Figure 4J-3(VA). Sequence for a Pedestrian Hybrid Beacon

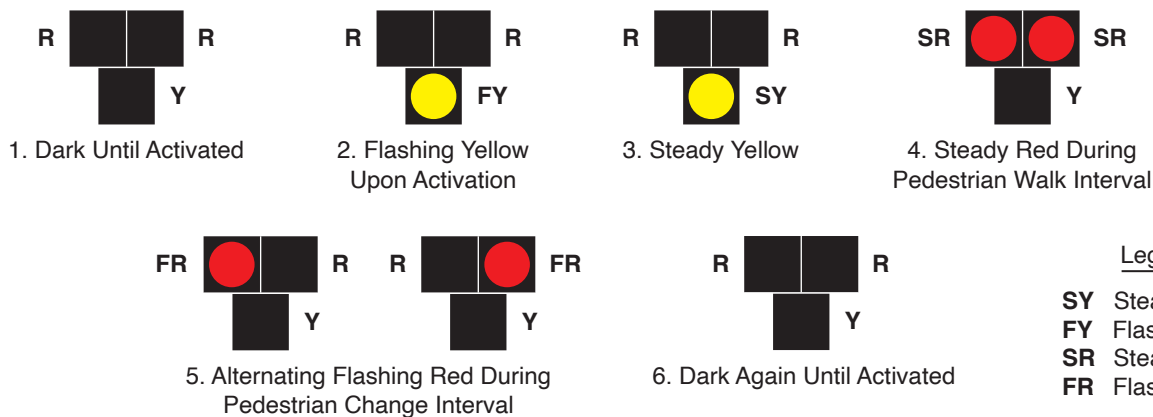
Note: An optional steady red clearance interval may be added after Interval 3, ~~and a 2 second -and-an-optional-short~~ buffer interval (alternating flashing red while the pedestrian signal heads are displaying a steady UPRAISED HAND) ~~may shall~~ be added after Interval 5.
